# 016

01/08/2006

# Technical Bulletin

## PowerGrip® Kit K015541XS for Ford 1.8 diesel engines

Fig. 1

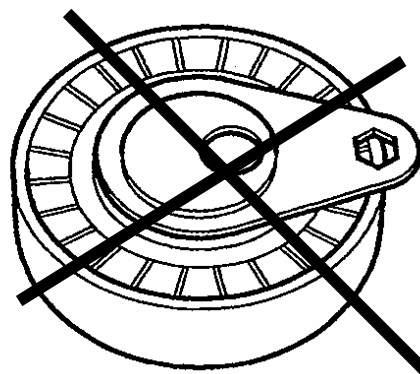
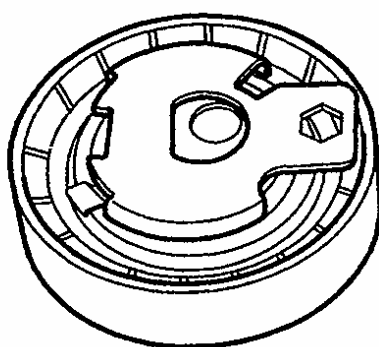
The very first models of the Ford Focus and Ford Fiesta, however, were initially equipped with a manual tensioner. Very shortly after the introduction of these vehicles, Ford decided in July 2000 to replace the manual tensioner by a new automatic tensioner. All cars originally equipped with the manual tensioner had to be refitted with an automatic tensioner.

Fig. 1 shows the old manual tensioner on the right side and the new automatic tensioner on the left.

Most of the manual tensioners have been replaced by the automatic one, so only a limited number of drive modifications should be expected. If you should encounter a vehicle that still needs the initial installation of the modified tensioner, there is no problem to do the replacement with our K015541XS.

Fig. 2

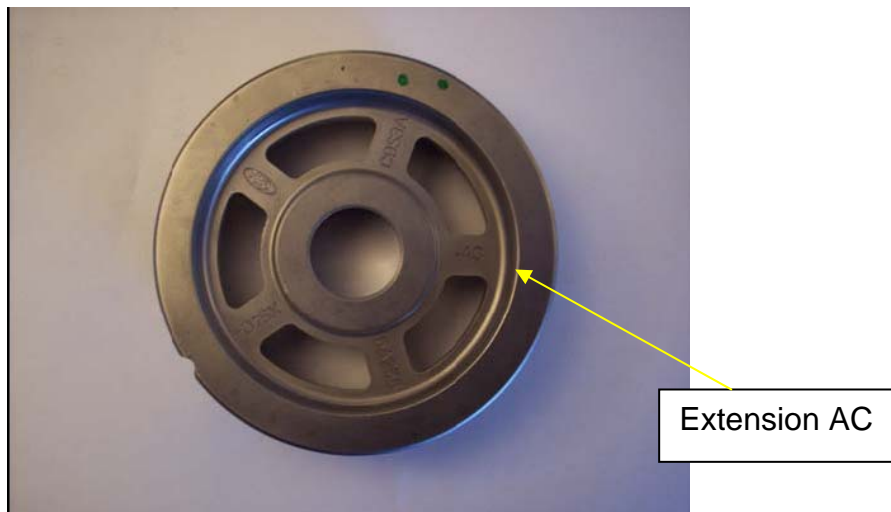
Check if the part number of the camshaft pulley ends with **AC** (Fig. 2). Should the part number of the camshaft pulley end with **AB**, fit new sprocket with OE ref. XS4Q6A256**AC**. Please note that Gates advises to check the version of the camshaft pulley during **any replacement** of this type of vehicle.

Fig. 3

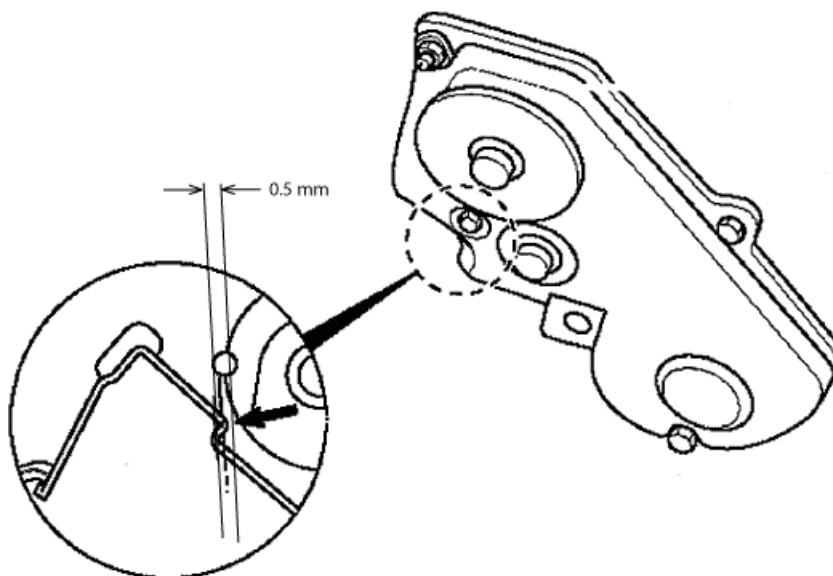
When the manual tensioner is replaced by an automatic tensioner, the timing belt cover has to be modified.

File off the inner corner (0.5 mm) as shown in Fig. 3. *Do not damage the timing belt cover by filing off too much of the corner!*
